VIRGINIA ELECTRIC AND POWER COMPANY
NORTH ANNA POWER STATION UNIT 2
RELIEF REQUESTS NDE-048 AND NDE-049 - ALTERNATIVE REPAIR TECHNIQUES
REQUEST FOR ADDITIONAL INFORMATION ON WCAP-14522

**Response to Request for Additional Information
WCAP-14552, "Structural Integrity Evaluation of Reactor Vessel Upper
Head Penetrations to Support
Continued Safe Operation of North Anna and Surry Units"
Revision 2**

**North Anna Power Station Unit 2
Virginia Electric and Power Company
(Dominion)**

STRESS INTENSITY FACTOR FOR THROUGH-WALL CIRCUMFERENTIAL FLAW IN CRDM

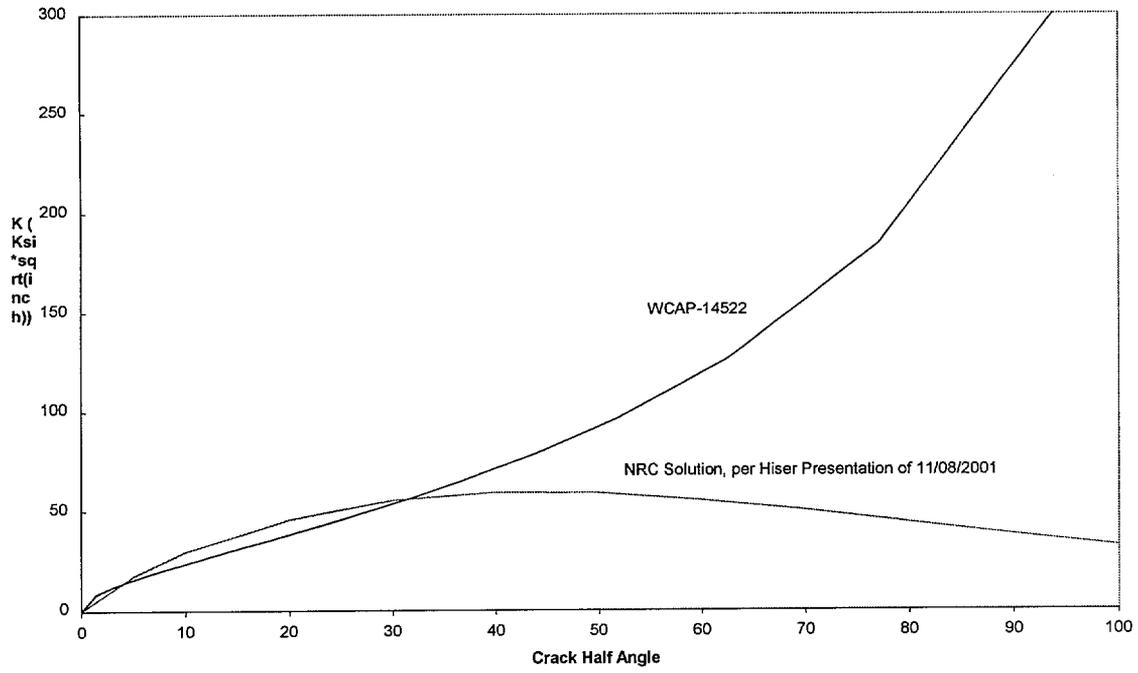
Page 6-2. Are you proposing to use the stress intensity factor formula for a through-wall crack in an infinite plate in the current application for through-wall cracks with either an axial or circumferential crack configuration? If so, provide estimation of the error associated with this approximation.

The through-wall flaw in a plate is conservative relative to the actual case. This can be verified by comparison of the overall stiffness of a plate with the stiffness of a thick-walled tube. The stress intensity factor for a given size flaw is proportional to the crack opening, and the crack opening is inversely proportional to the stiffness. This part of the work contained in WCAP 14552 was not used in the evaluation of the flaws found, since they were surface flaws. As an example, the recently developed expression by Structural Integrity Assoc. for a through-wall circumferential flaw has been contrasted with the plate expression in the attached figure, "Stress Intensity Factor For Through-Wall Circumferential Flaw In CRDM," where it can clearly be seen that the plate expression is conservative.
